COMMUNITY BOARD FEEDBACK PACKAGE

DINING OUT NYC

Business Name: Anejo

Cafe Address: 668 10 Avenue, New York, NY, 10036

Sidewalk Cafe Site Plan Form

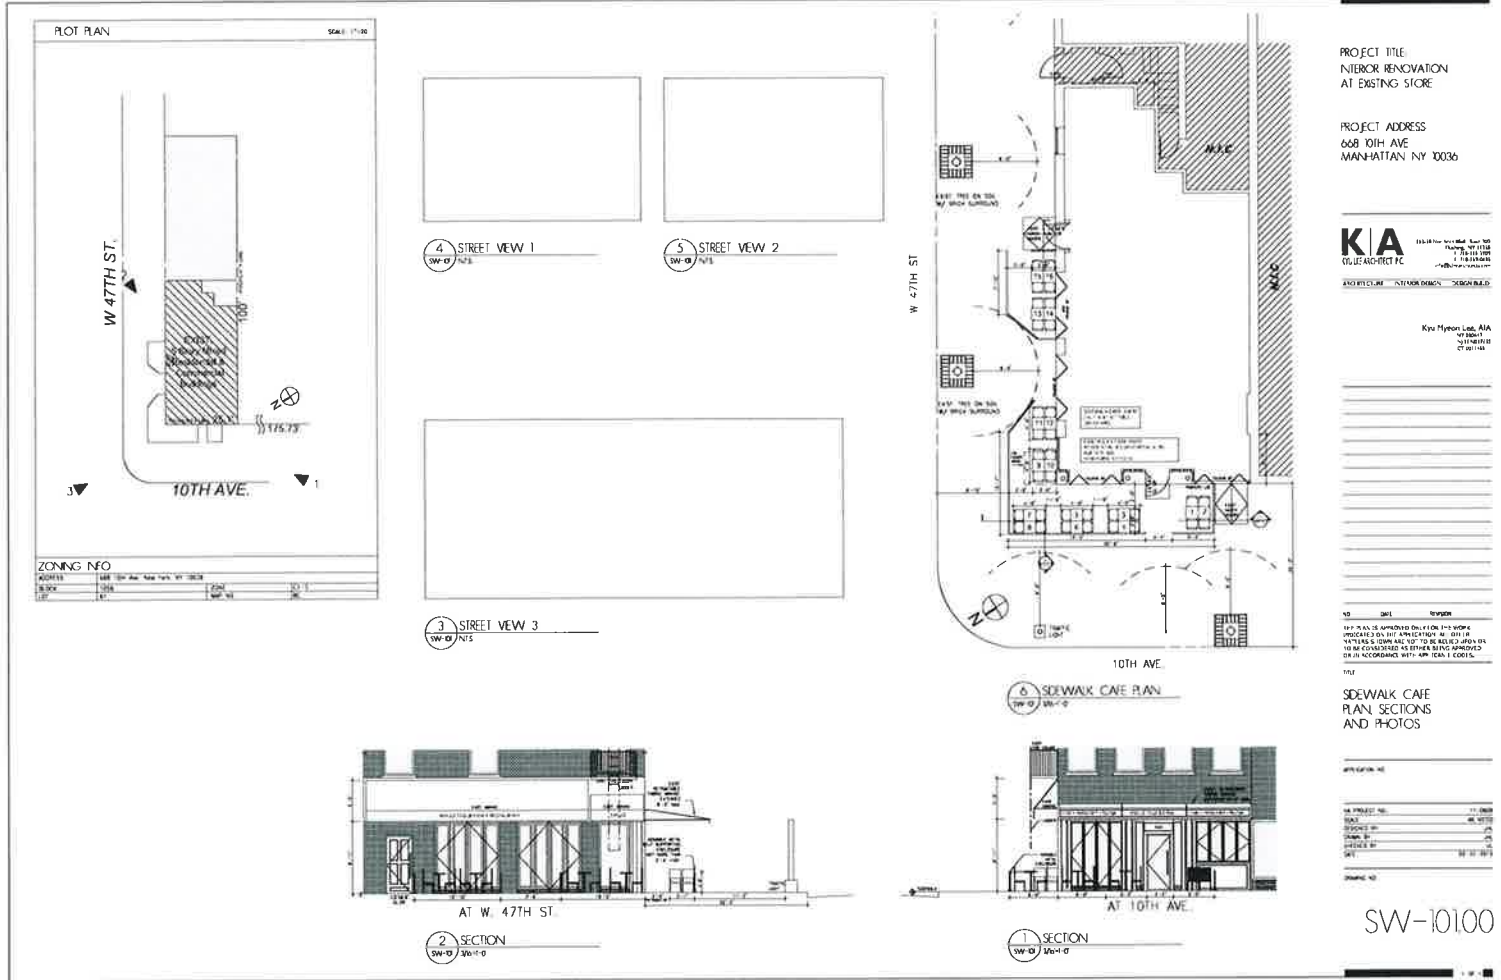
Measurements on the original Site Plan are incorrect and do not provide for the required clearances from obstructions such as street tree beds and pedestrian ramps and do not provide for the required 8 foot clear path

To provide for the required 8 foot clear path and the 8 foot clearance between the cafe perimeter and the obstructions, MCB4 requests that the sidewalk cafe be reduced in size to 12 tables/24 seats and that certain tables be relocated. The applicant has agreed to these changes and prepared the attached Revised Site Plan reflecting the reduction and rearrangement of the cafe layout.
